Econ Place PD

Econ Trails Concept Plan

Request

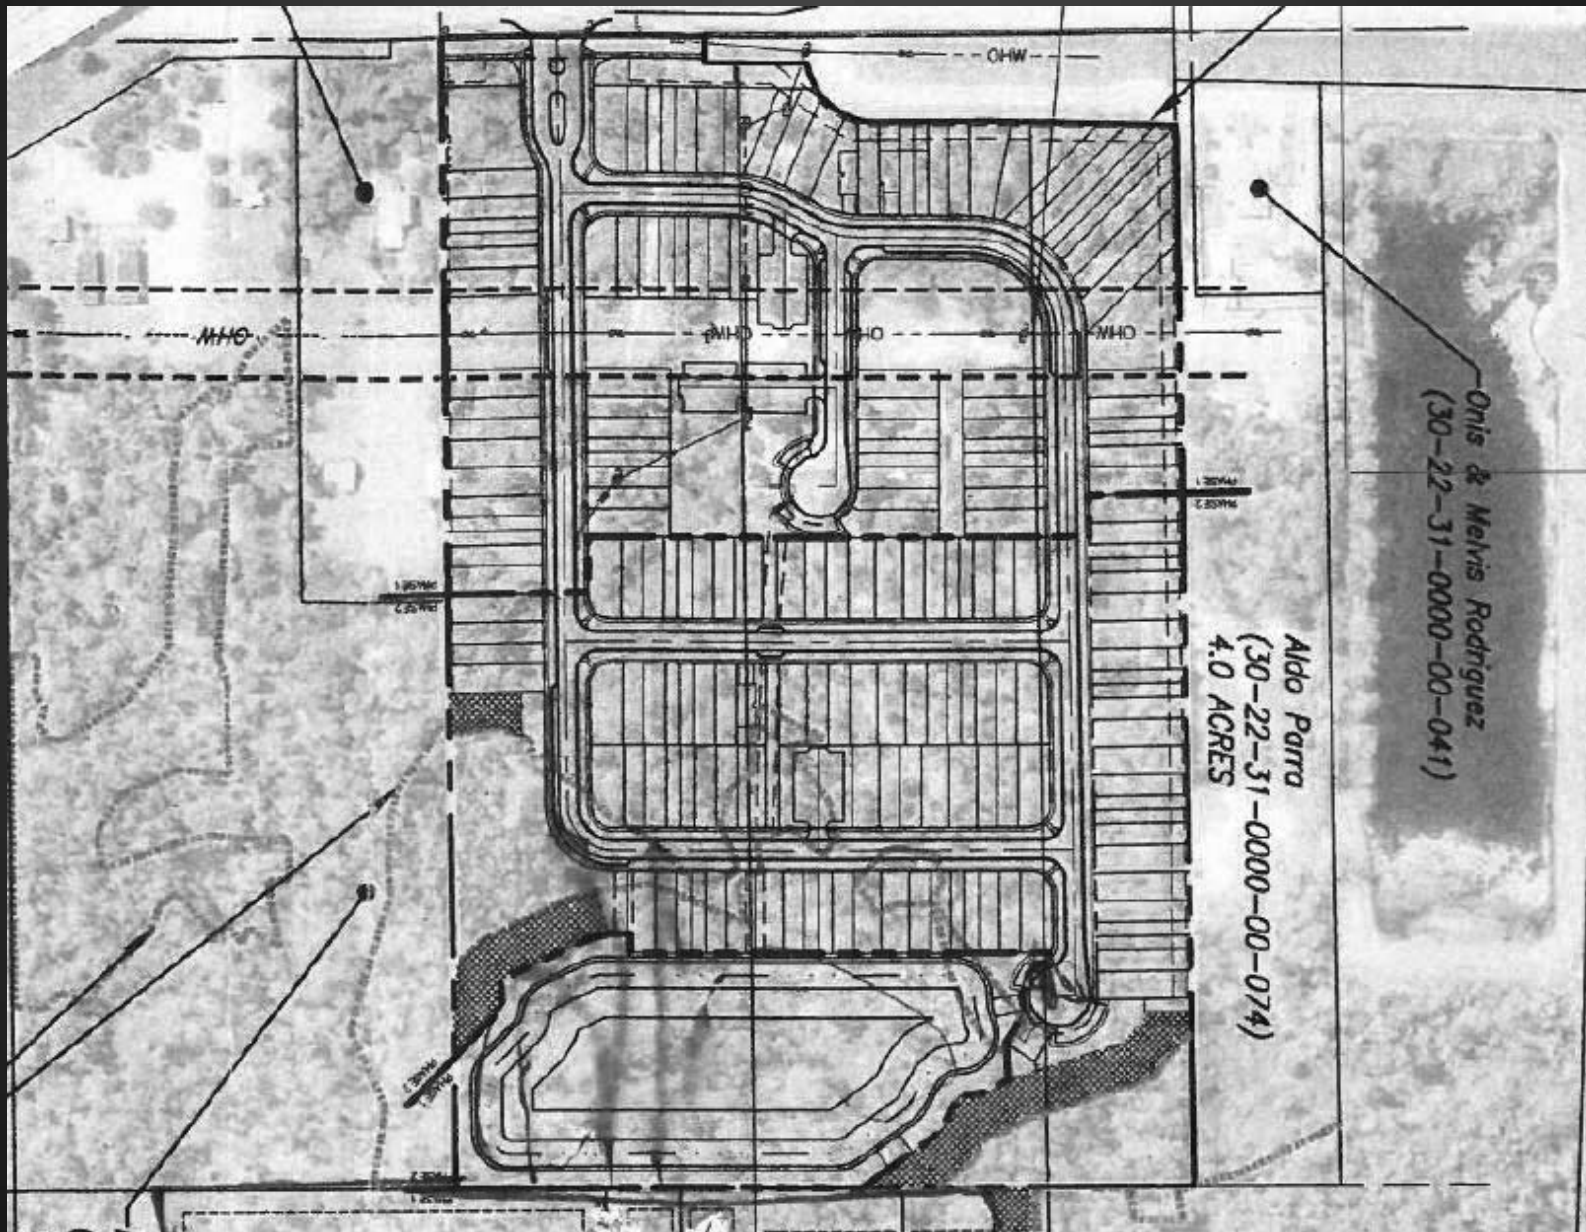
- Clarify COA #16 to state “The project shall interconnect to adjacent property to the east at the time of the Preliminary Subdivision Plan (PSP) review.”

- Add an arrow to the east with a note “exact location to be determined at PSP”

- OBJ T3.2 Orange County shall require the local street, pedestrian and bicycle network to be designed to promote interconnectivity and to allow access to surrounding single-family residential, multi-family residential, non-residential and mixed land use. (Policies 2.1.1-r, 2.1.1.1-r, 2.1.1.4)

- Policy T3.2.1 The County shall require development to provide cross-access easements or public right-of-way stubouts to adjacent parcels when such connections will improve connectivity and enhance access to surrounding land use. Provisions for future connections shall be provided in all directions, except where abutting land is undevelopable.

- Section 34-174 (d): If the contiguous landlocked property (platted or unplatted) is not agriculturally zoned and is developable, then a fifty-foot right-of-way stub shall be dedicated to the adjoining unplatted or platted areas to provide access to such areas and to provide for property traffic circulation in the future.
